Gordon County Health Department

RE: Talking Rock Creek Properties #13

Soil Analysis Report

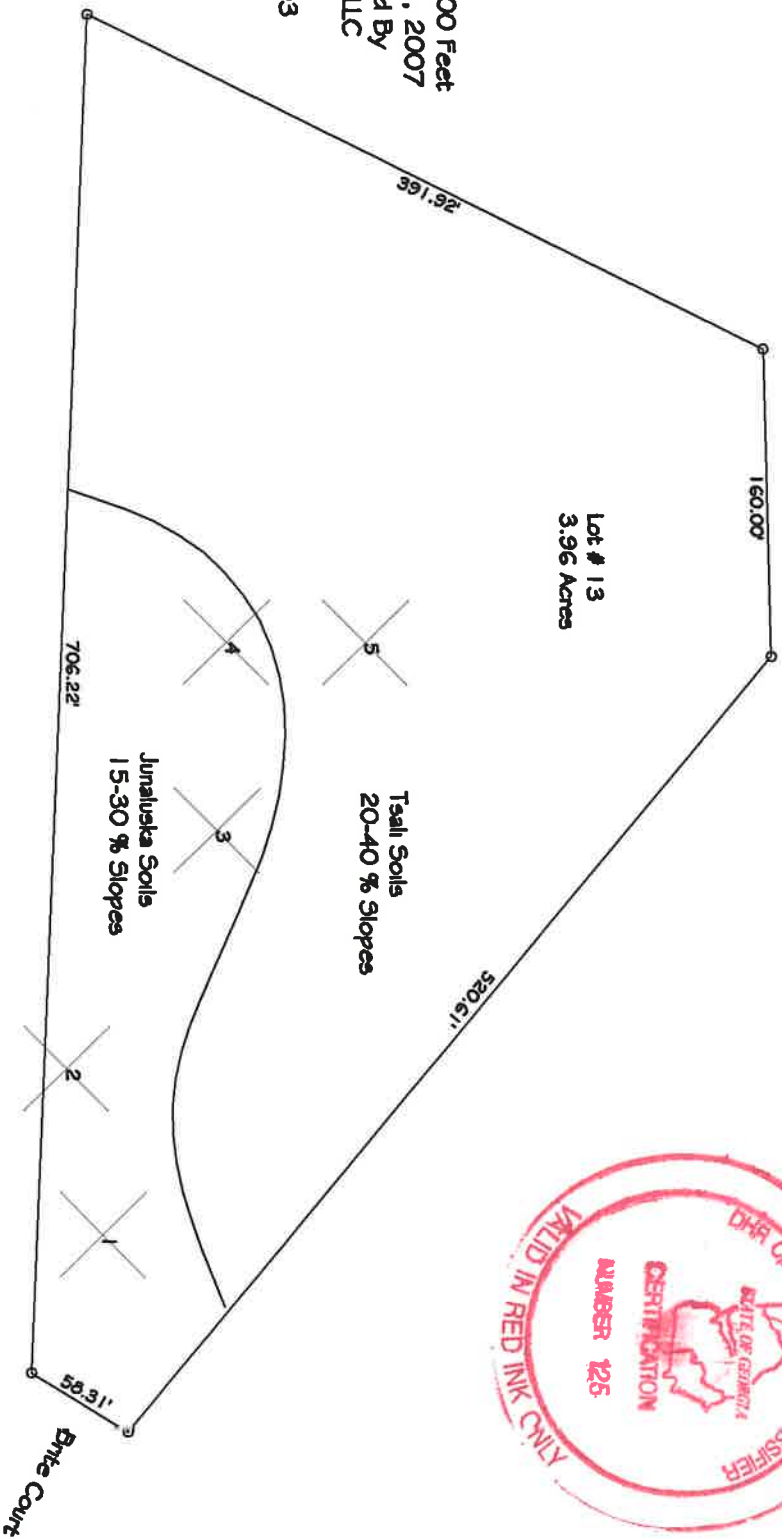
The Gordon County Environmental Health Office has reviewed the soil test that you submitted to our office for review. The area classified as Junaluska soils (test pits 1, 2, 3 and 4) will be the area best suited for a conventional septic tank system. This is the area on top of the ridge, therefore your home needs to be situated so this area can be used for drainfield. If an area other than the front, near the cul de sac, is used for house placement, a sewage rated effluent pump may be needed to access the drainfield up slope.

The rules and regulations for septic tank systems, Chapter 290-5-26, states, "Slopes of more than 25 percent shall be considered unsuitable unless the application for the construction permit includes the results of a special investigation by a soil classifier which demonstrates that the slope limitation can be overcome by design or site modifications." This would pertain to the Tsali soils, 20% - 40% slope.
